The Sizewell C Project

2.8 Ch Two Village Bypass Plans for Approval

July 2021

Two Village Bypass Plans For Approval – Revisions Schedule

DRAWING TITLE:
TWO VILLAGE BYPASS PROPOSED GENERAL ARRANGEMENT AND PROFILES SHEET 1 OF 2

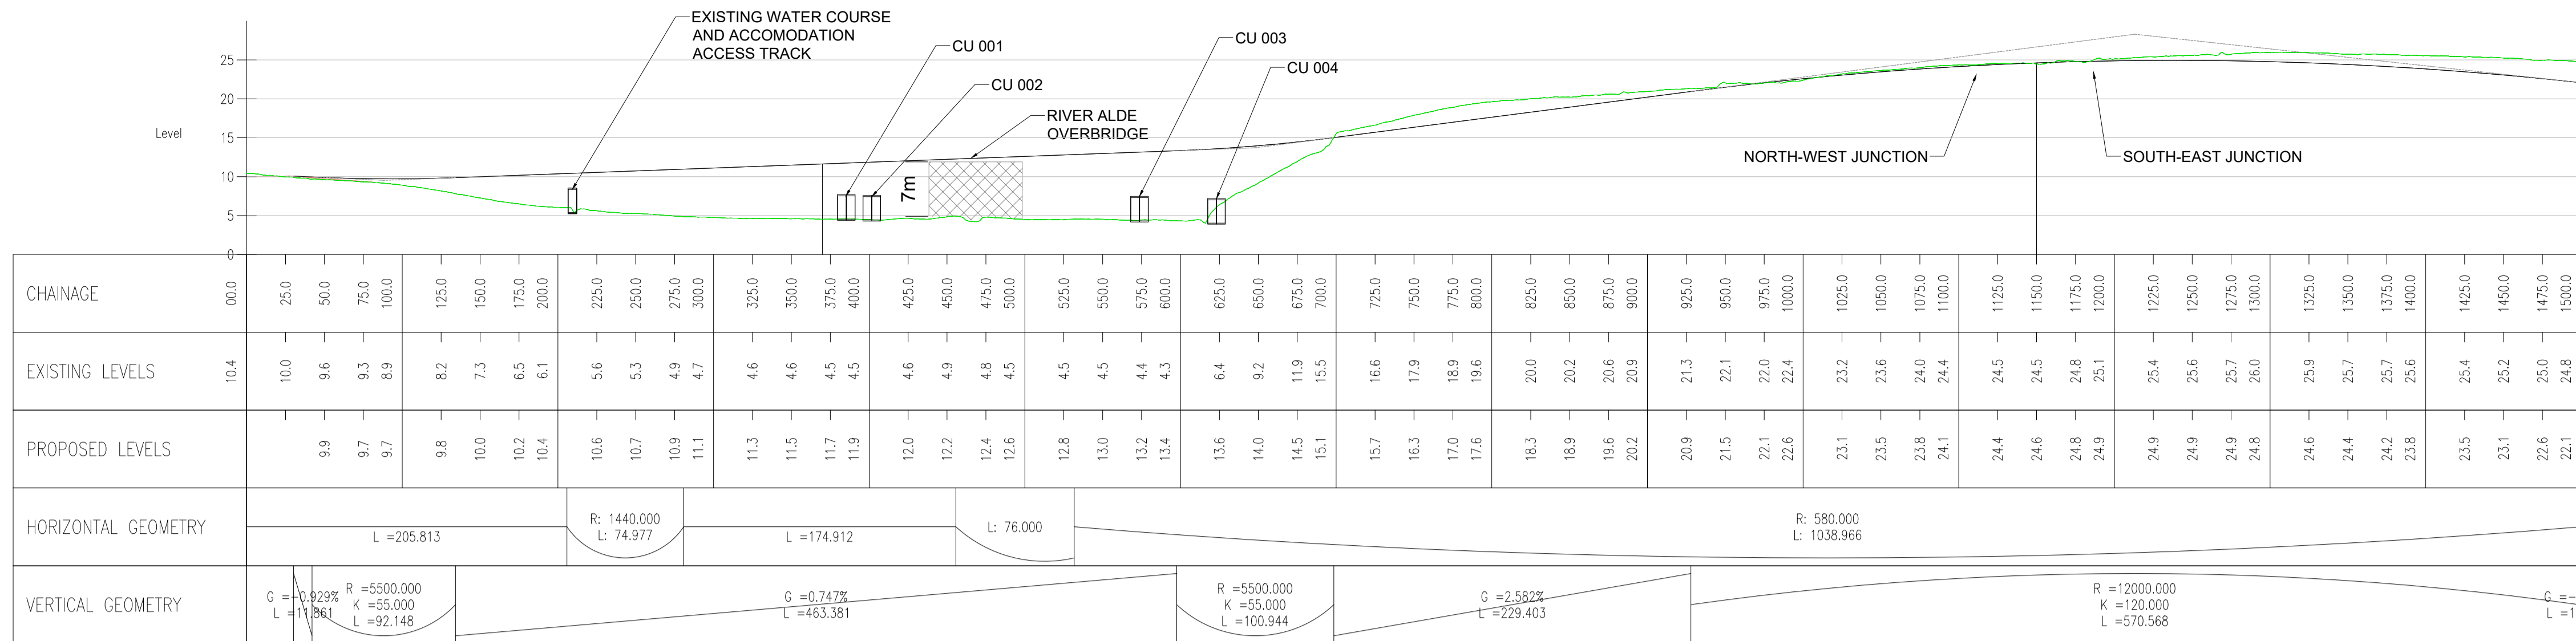
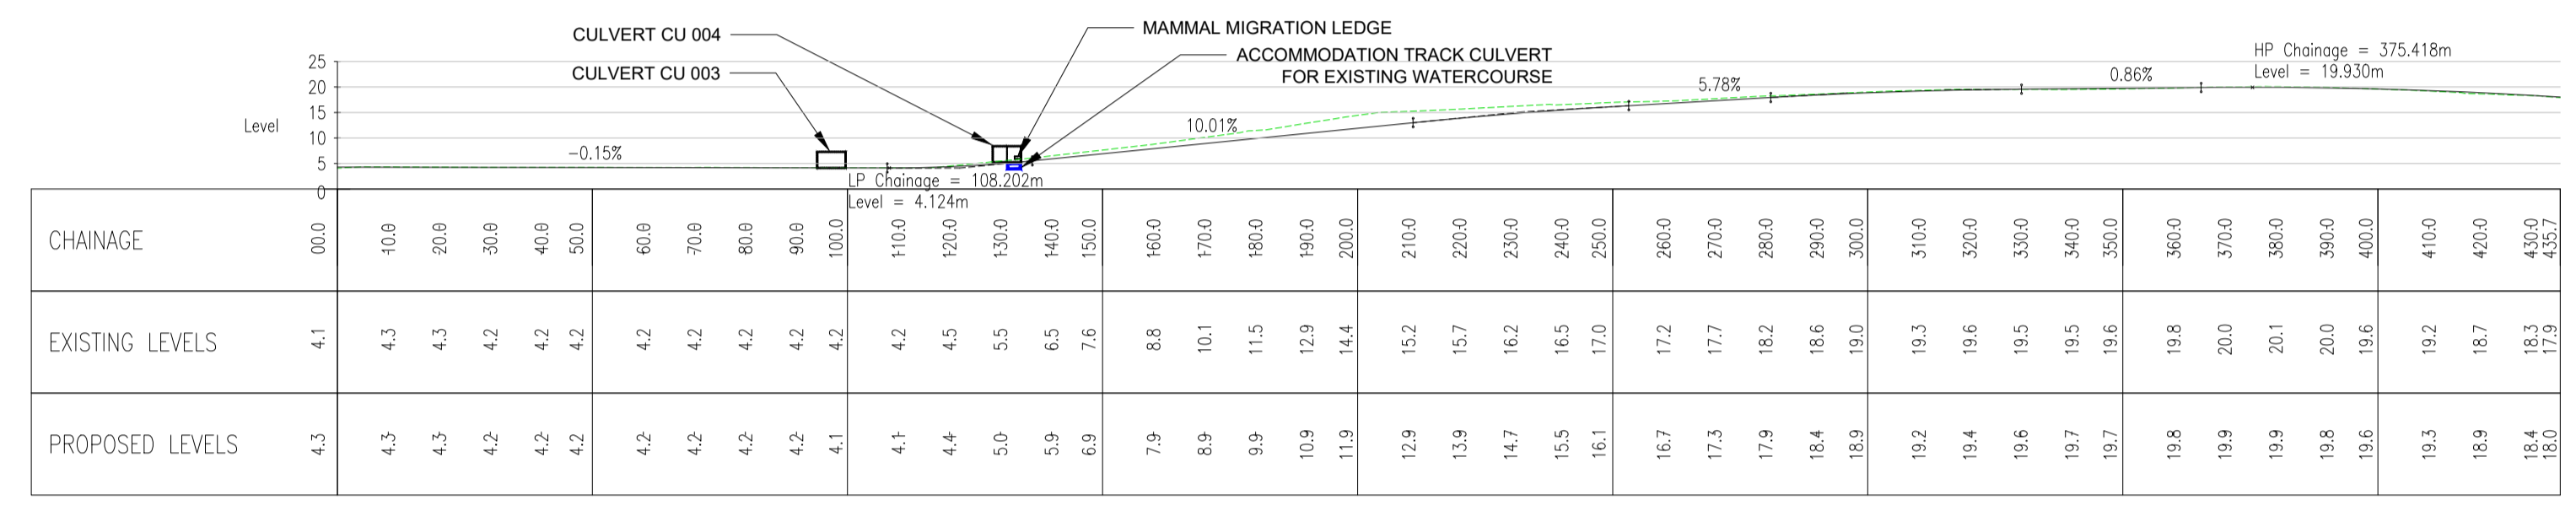
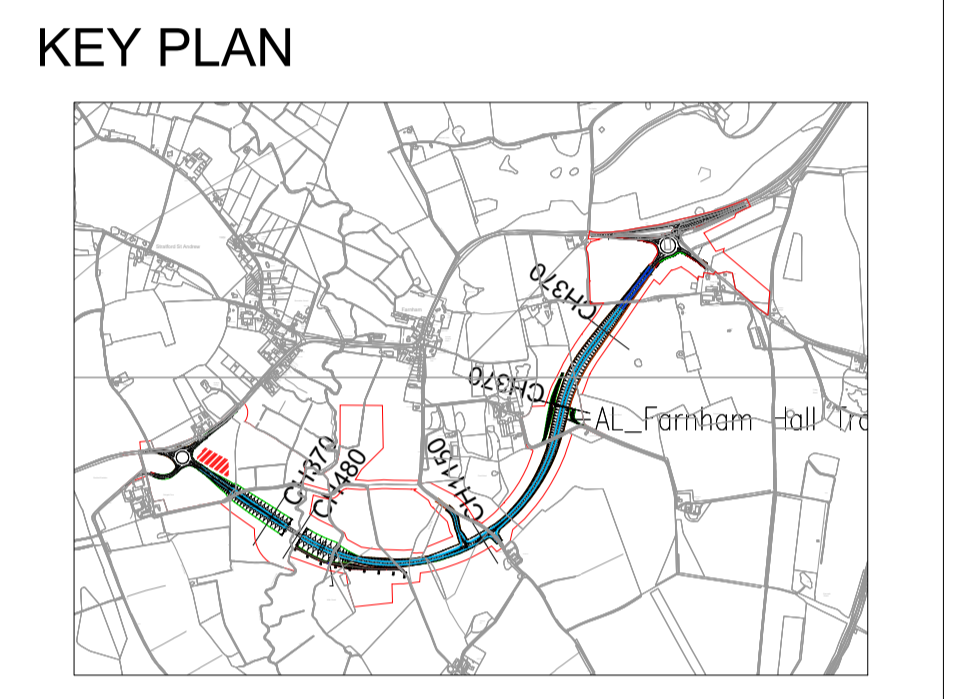
Drawing Number	Revision	Drawing Title	Amendments
SZC-SZ0204-XX-000-DRW-100038	03	Two Village Bypass Proposed General Arrangement And Profiles - Sheet 1 of 2	Reflect changes to Order Limits and proposed design of culverts and adjacent accommodation track east of the River Alde overbridge.
SZC-SZ0204-XX-000-DRW-100522	03	Two Village Bypass Proposed General Arrangement And Profiles - Sheet 2 of 2	Reflect changes to Order Limits, proposed design of culverts and adjacent accommodation track east of River Alde overbridge and proposed NMU.
SZC-SZ0204-XX-000-DRW-100039	03	Two Village Bypass A12/A1094 Eastern Roundabout Proposed General Arrangement	Reflect changes to proposed NMU at A12/A1094 roundabout.
SZC-SZ0204-XX-000-DRW-100040	02	Two Village Bypass A12 Western Roundabout Proposed General Arrangement	No updates made.
SZC-SZ0204-XX-000-DRW-100450	01	Two Village Bypass A12/A1094 Eastern Roundabout Proposed Profiles	No updates made.

DRAWING TITLE:
 TWO VILLAGE BYPASS
 PROPOSED STAGGERED JUNCTION
 PLAN AND PROFILES

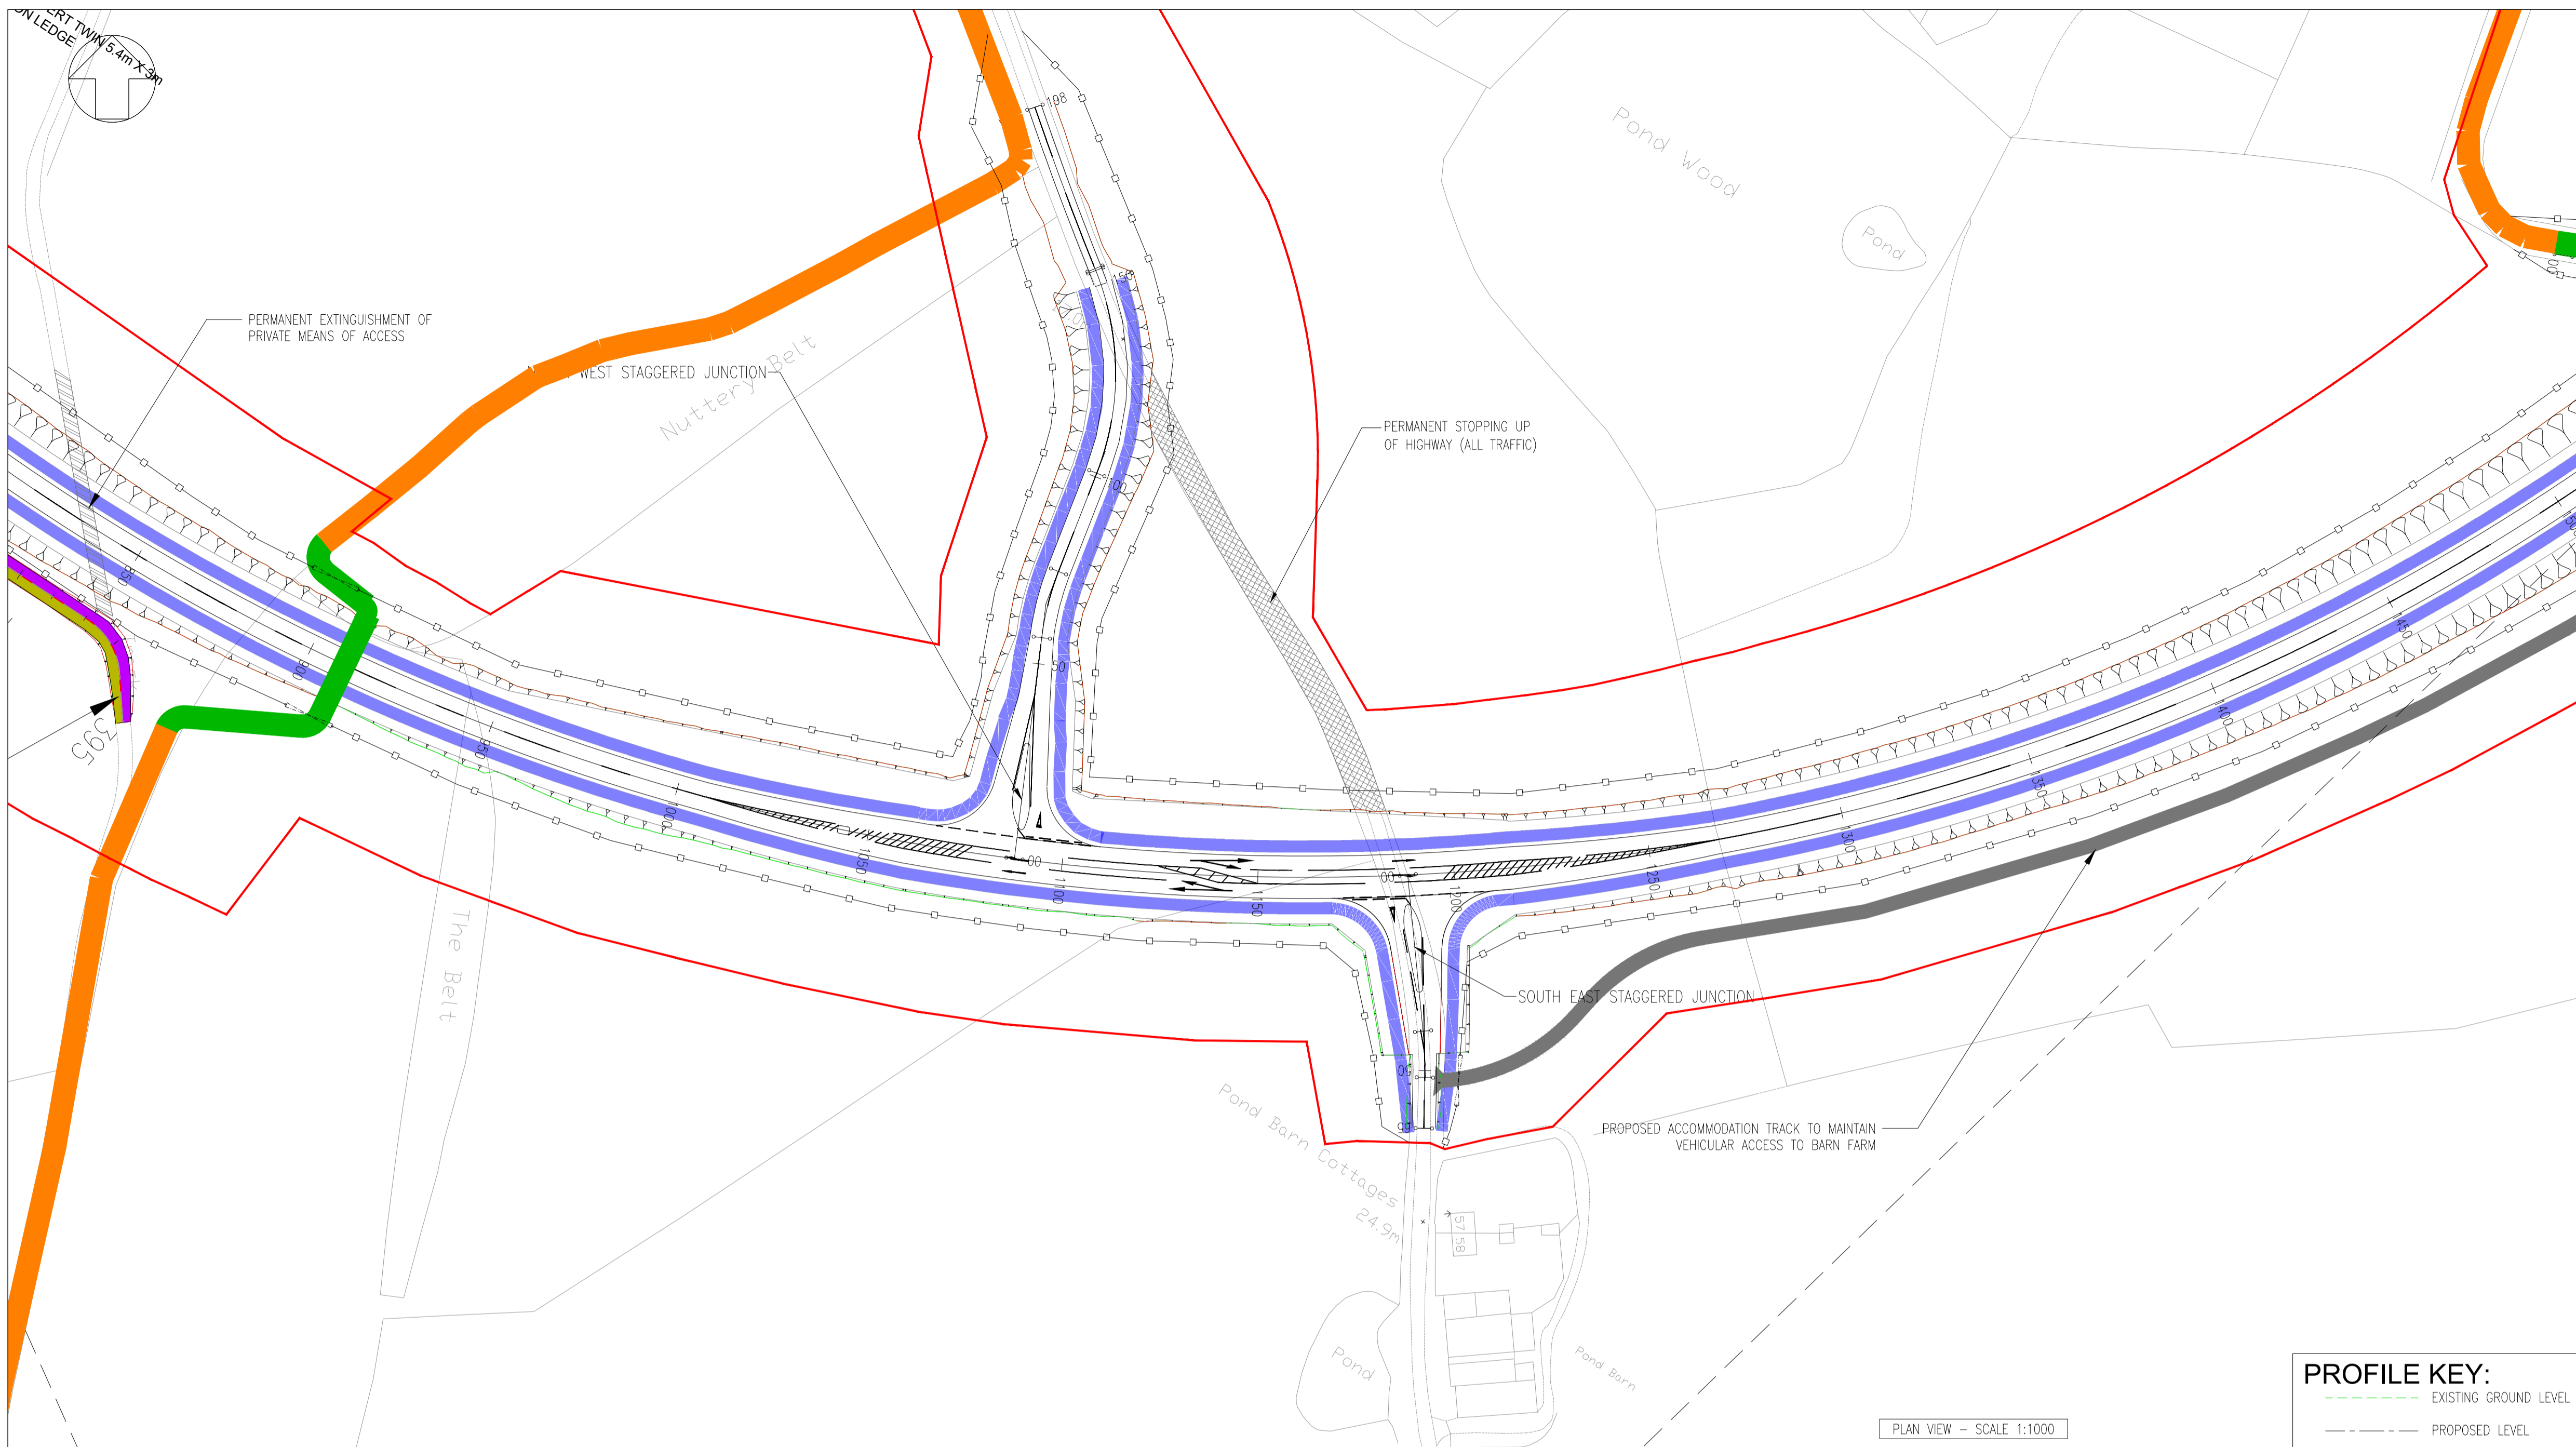
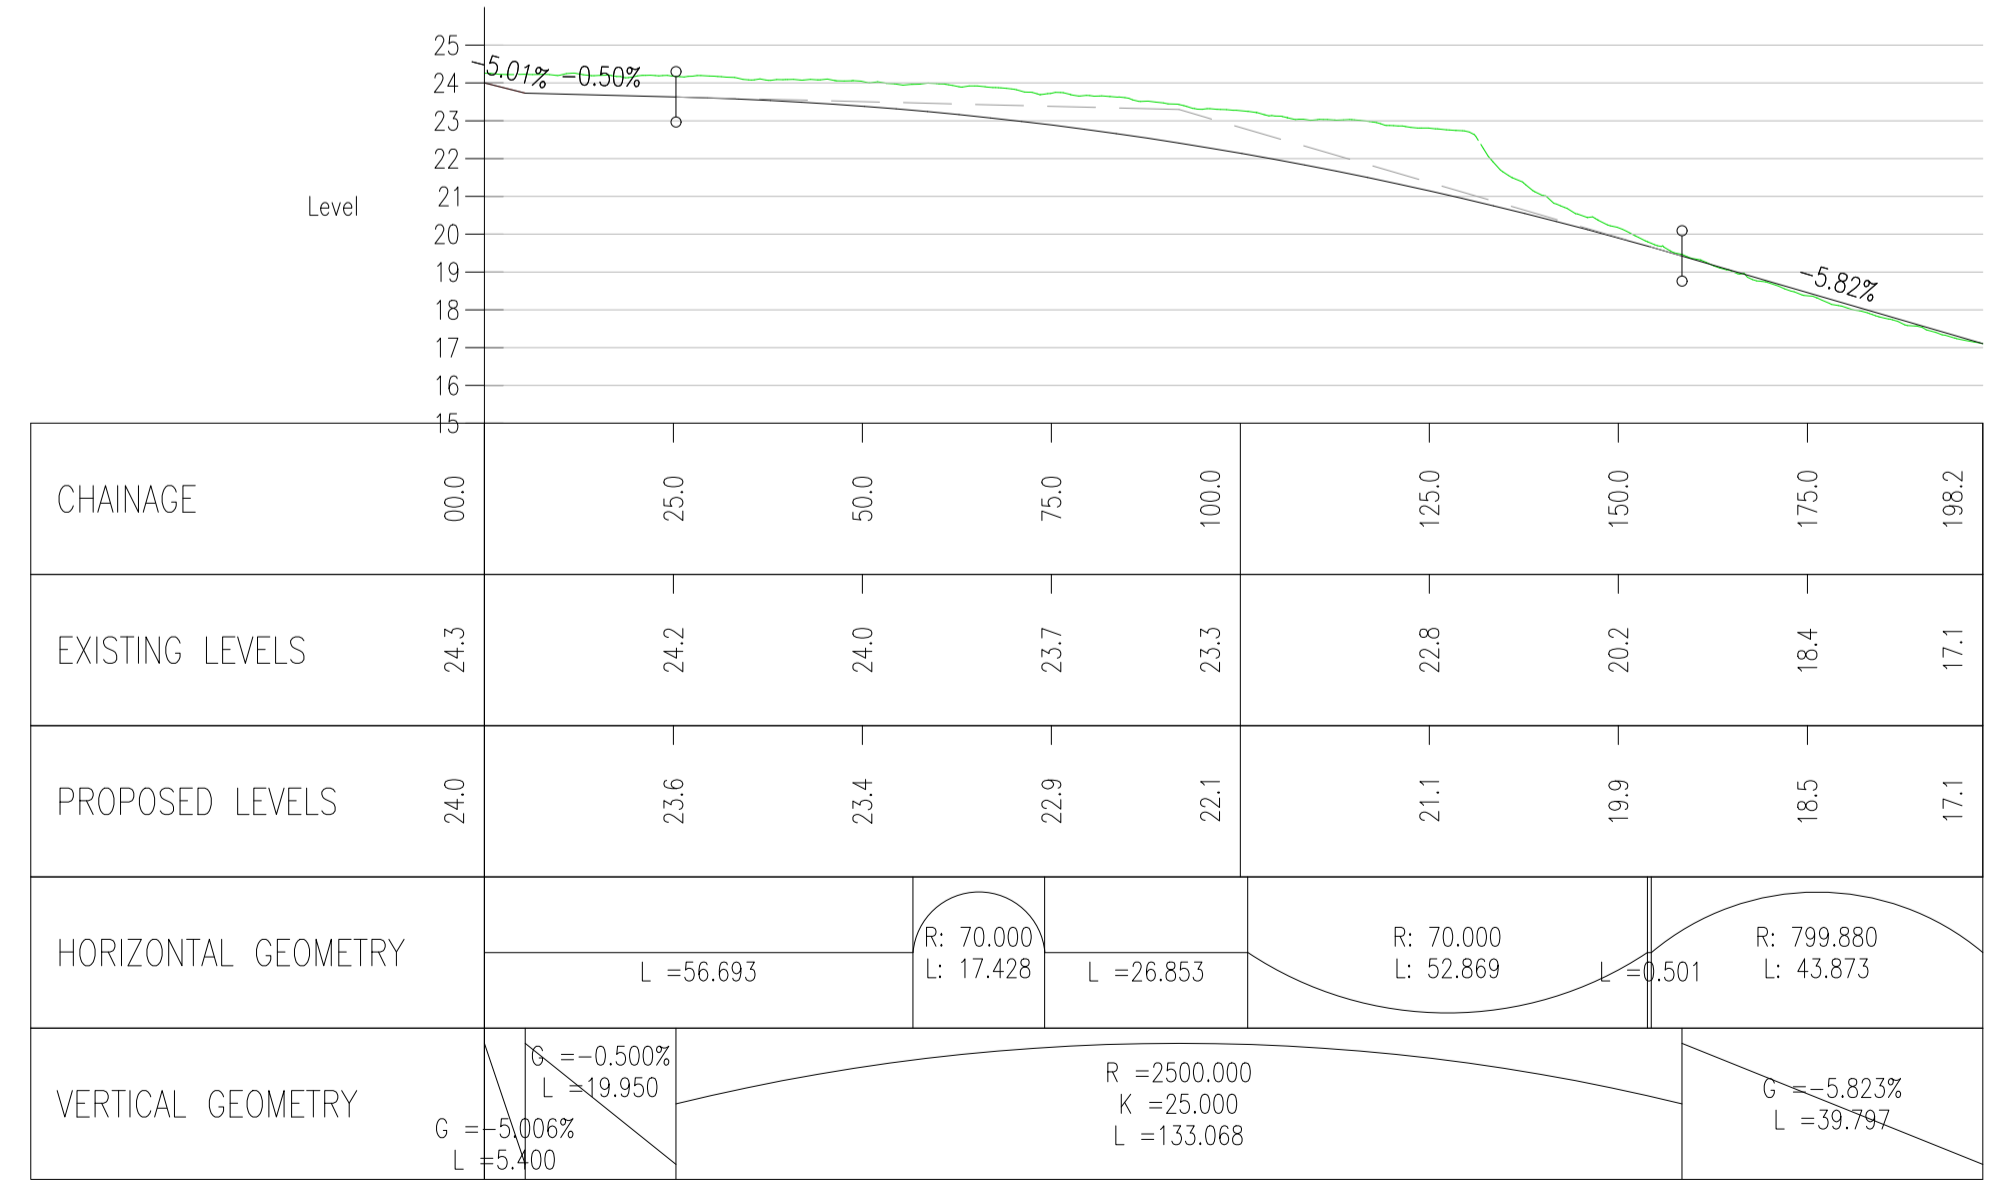
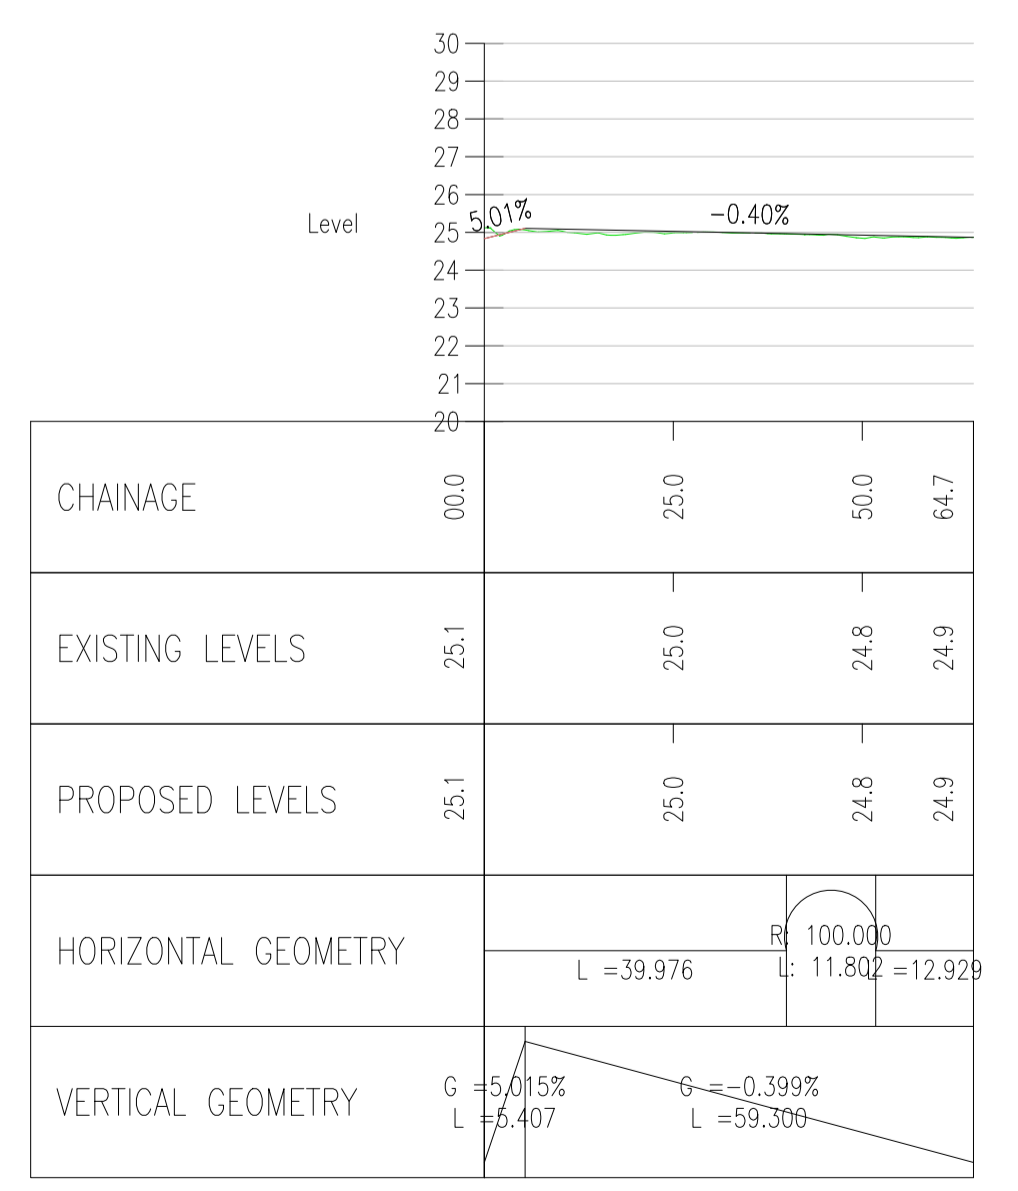
SZC-SZ0204-XX-000-DRW-100451	01	Two Village Bypass A12 Western Roundabout Proposed Profiles	No updates made.
SZC-SZ0204-XX-000-DRW-100452	03	Two Village Bypass Proposed Staggered Junction Plan And Profiles	Reflect changes to accommodation track east of River Alde overbridge.
SZC-SZ0204-XX-000-DRW-100293	01	River Alde Overbridge Proposed General Arrangement And Elevation	No updates made.
SZC-SZ0204-XX-000-DRW-100290	01	Foxburrow Wood Footbridge Proposed General Arrangement And Elevation	No updates made.
SZC-SZ0701-XX-000-DRW-100166	03	Two Village Bypass Proposed Landscape Masterplan And Finished Levels - Sheet 1 of 2	Reflect changes to Order Limits and proposed design of culverts and adjacent accommodation track east of the River Alde overbridge.
SZC-SZ0701-XX-000-DRW-100167	03	Two Village Bypass Proposed Landscape Masterplan And Finished Levels - Sheet 2 of 2	Reflect changes to Order Limits and proposed NMU at A12/A1094 roundabout.
